Subject: LaSalle County Station Units 1 and 2
Dynamic Qualification Review Program -
Supplemental Response
NRC Docket Nos. 50-373/374

MEMORANDUM OF
TELEPHONE CONVERSATION

Calcs. For SBGTS Primary Fan	
X	Safety-Related
	Non-Safety-Related

SBGTS PRIMARY FAN - TEST MODEL - SCHEMATIC REPRESENTATION

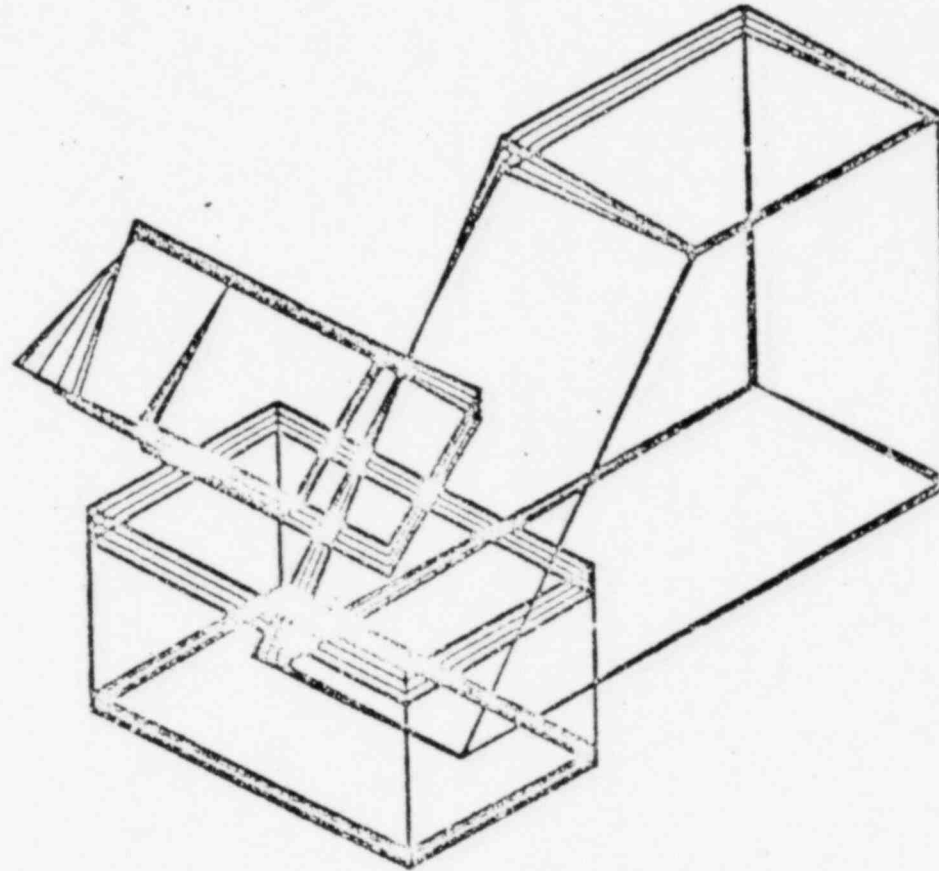
Frequency #6 p. N6 indicating vertical vibratory motion of the motor base lies in a non ZPA range [p.N10-13]. All other frequencies determined by test, lie in the ZPA range. The importance of this frequency is assessed in the next section.

Equipment frequency #6 indicates vertical vibratory motion of the motor base both at the ground (where it is restrained by bolts) as well as at the top of the motor base. The apparent ground motion of the motor base p. N6 is attributed to bending motion of the motor base mounting element. Since only four edge monitoring stations describe the motion of the base of the motor support, this motion is spuriously shown as vertical translational motion. This frequency corresponds to an acceleration of 1.05g. For frequencies greater than 32.5 Hz, the response spectra curve is monotonically decreasing until the ZPA plateau is reached [p.N10-13].

In the analytical determination of the equipment-frequencies, the equipment was considered rigid. In the impedance test a 32.5 Hz frequency in the vertical direction was observed. This frequency falls close to the ZPA range, see pages N10-13. All other frequencies are higher and fall in the ZPA range.

An acceleration of 1.05g corresponding to a frequency of 32.5Hz is shown in the response spectra curves pages N10-13. To account for the effect of the two higher frequencies (#4 and #5) an amplification factor of 1.5 is conservatively used. This results in an effective acceleration of 1.55g, this value is higher than the 1.3g value for which the equipment is qualified (though the motor is qualified for 7.2g). To determine equipment stress and displacement adequacy for the higher g value (1.55g) equipment maximum stresses in the vertical direction are scaled by the ratio of the required acceleration level (1.55g) to the acceleration level for which the equipment was qualified (1.3g), if these stresses are within allowable levels the equipment is qualified for the higher g-value. Shown below are maximum stresses and displacements corresponding to an effective acceleration of 1.55g in the vertical direction, equipment qualification along horizontal axes remains unchanged. (The original maximum stress/displacement table is given on page N6 which is reproduced from EMD File No. 014360 and was transmitted at an earlier date with the Regualification Certificate.

The revised stresses and displacement are will within allowable values. Equipment integrity under the higher acceleration level is thus assured.

REQUIRED RESPONSE SPECTRUM CURVE

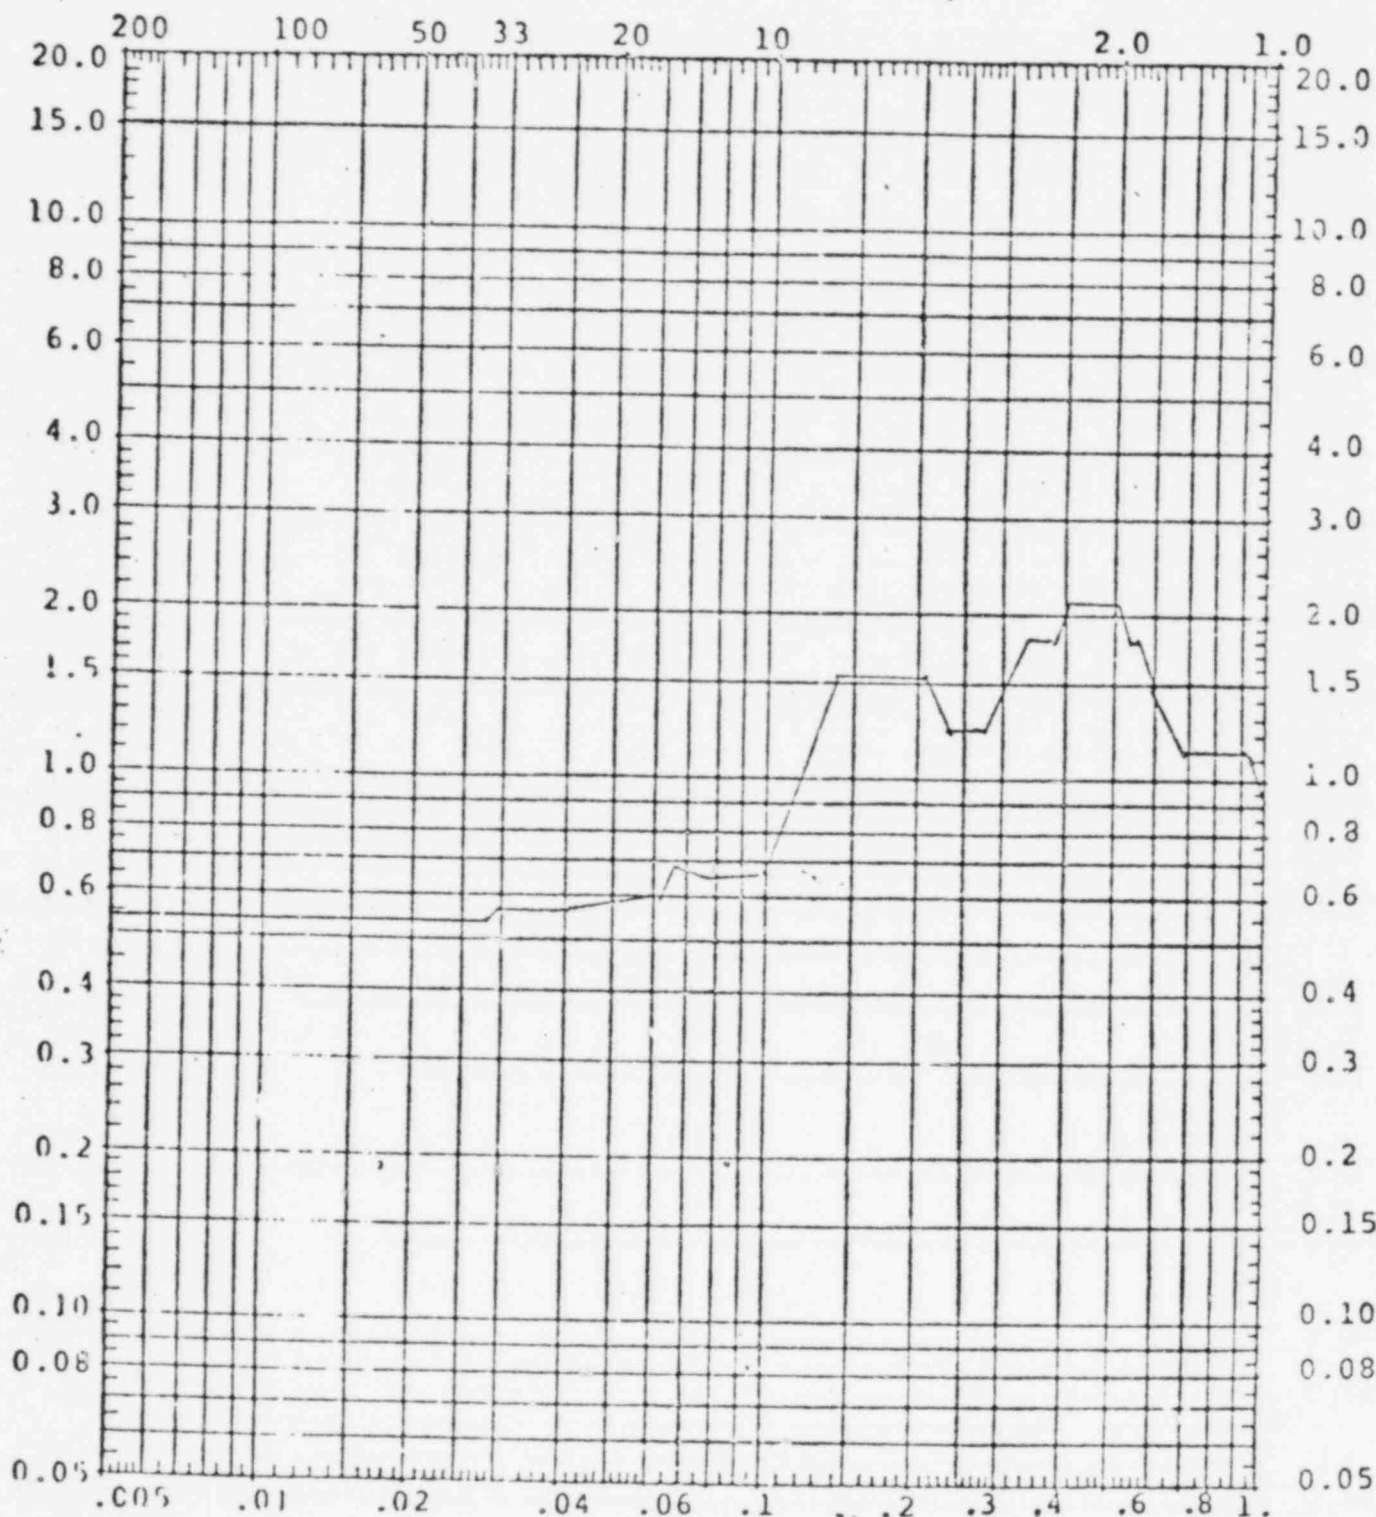
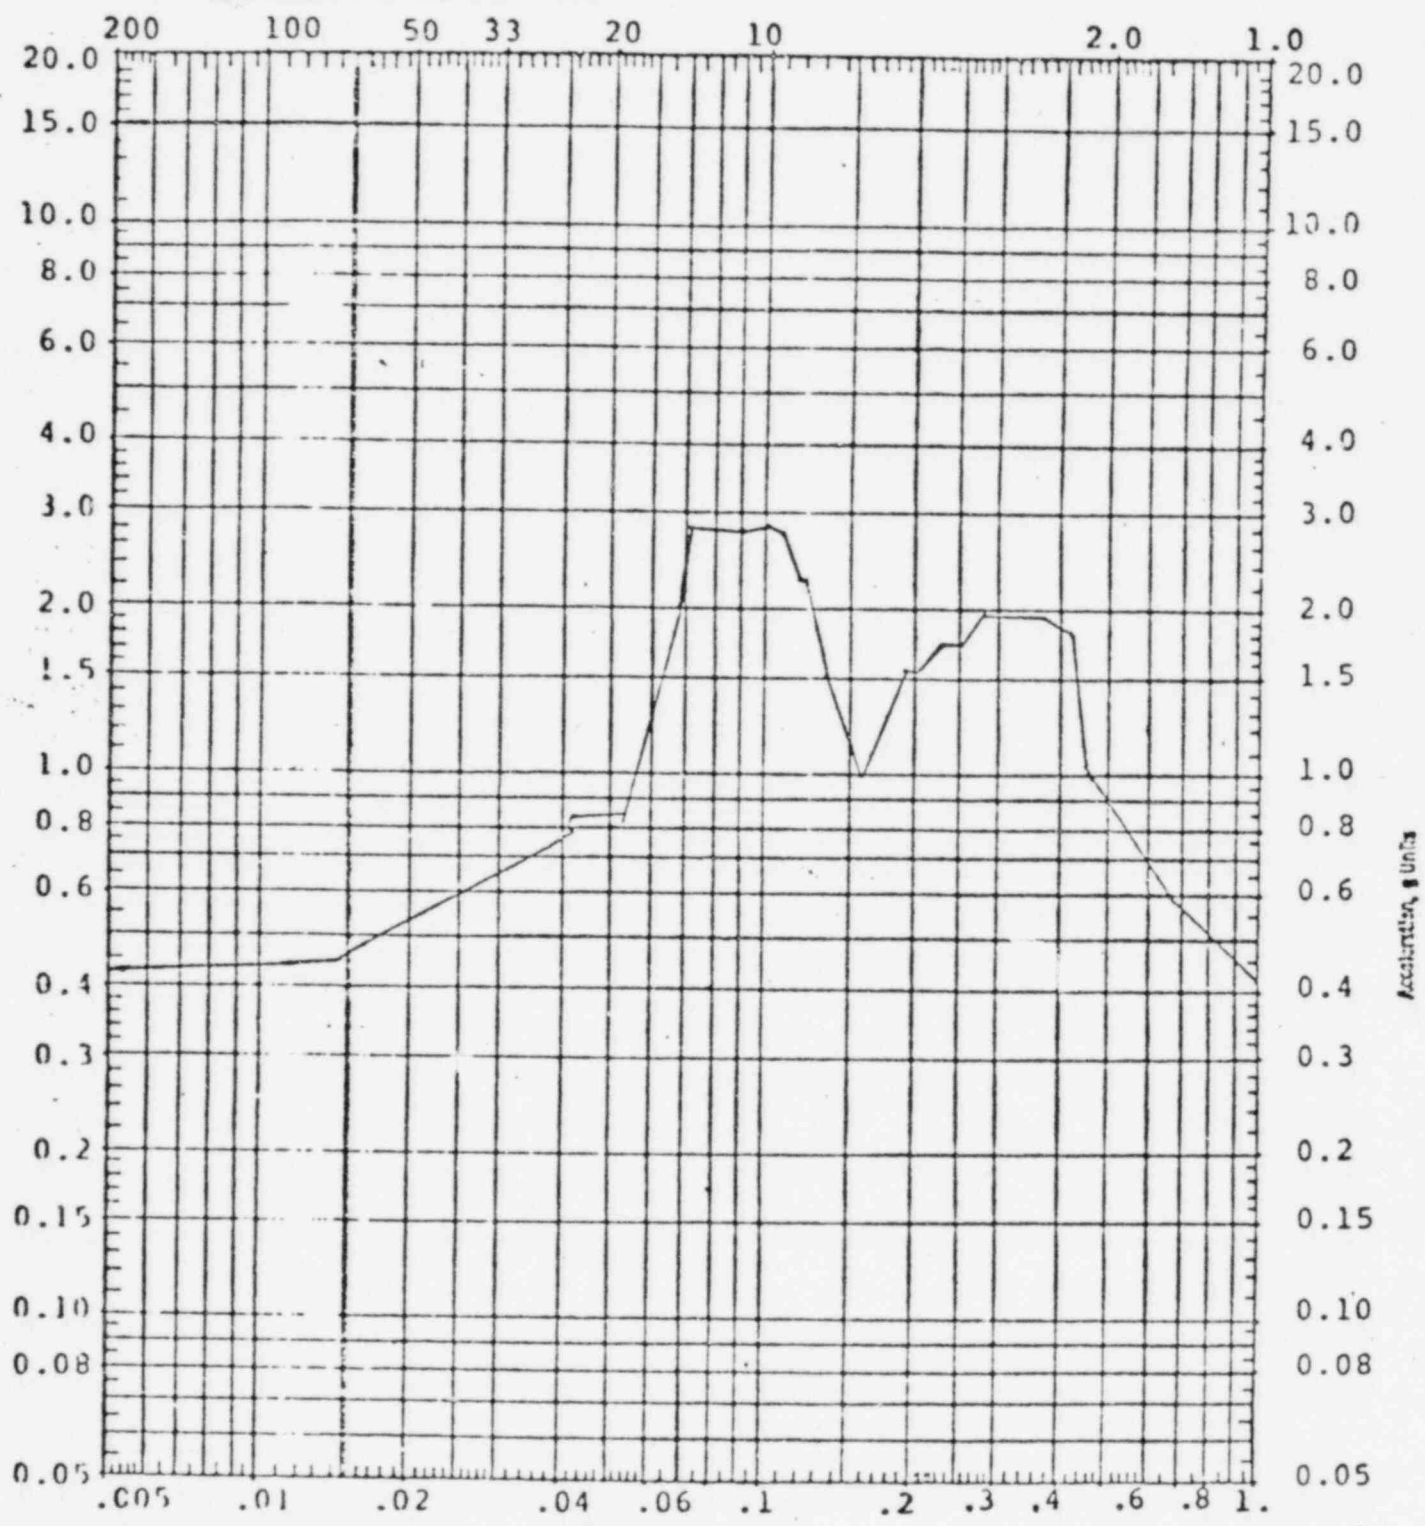
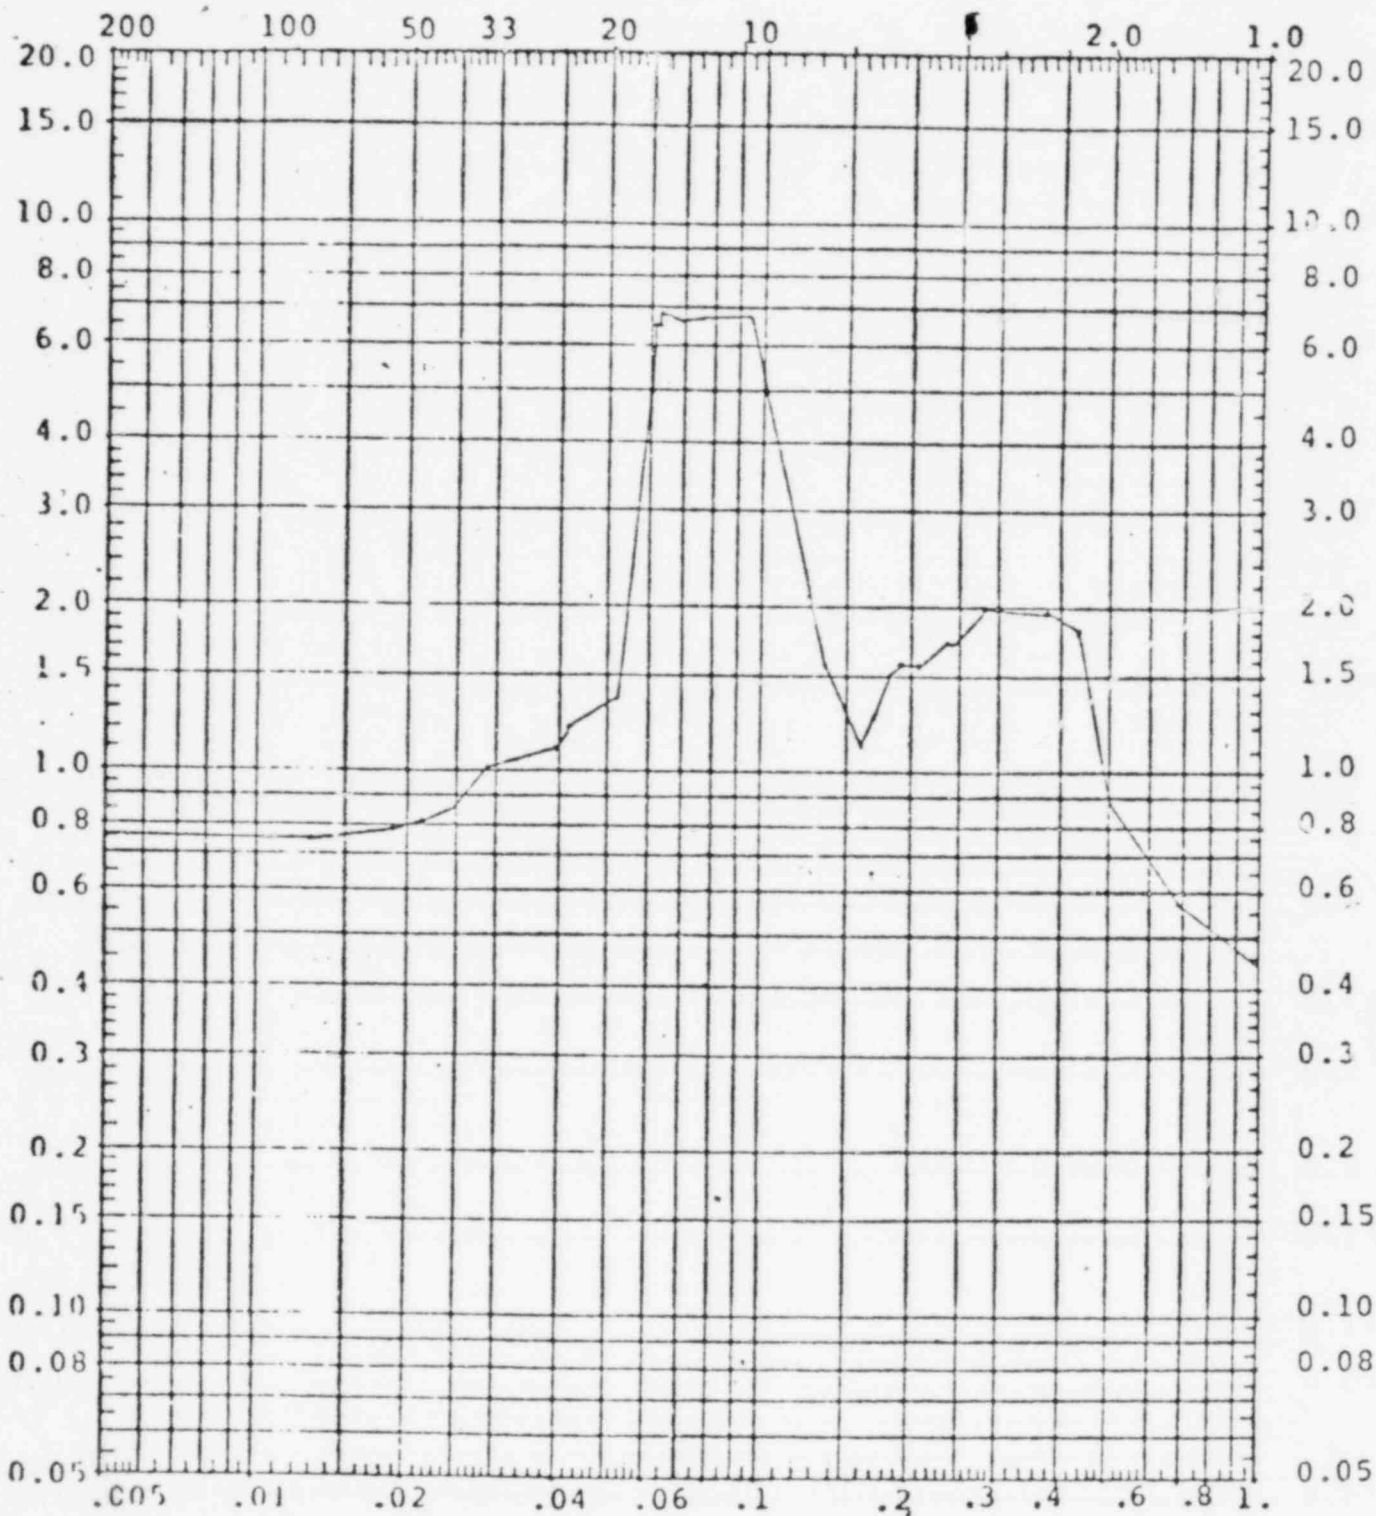
1. SGTS Equipment Train: - NRC & EGG wanted to know about nozzle stress analysis. S&L explained that this was included in our transmittal on 3-10-81, EMD No. 028847. (Vol. 5)
2. S&L clarified to NRC & EGG about the SGTS Control Panel, which model is for Impedance Test and which is the qualification test. We also assured them that we witnessed the impedance test and did not see any concern in vertical direction as we did not see any resonances in vertical direction.
3. NRC & EGG questioned the three natural frequencies found in the vertical direction in Impedance Test namely 32.5 Hz, 46 Hz, & 49 Hz for SGTS fan.

We explained to them that they do not fall in any peak zone of the response spectrum curve and the response spectrum curve itself is

starting to go down to ZPA levels. We also explained to them that we have used 1.3g in analysis even though the σ level at 32.6 Hz is 1.05g and showed them that we still have good margin in stresses. We also agreed to write our reasoning in a submittal to them next week.
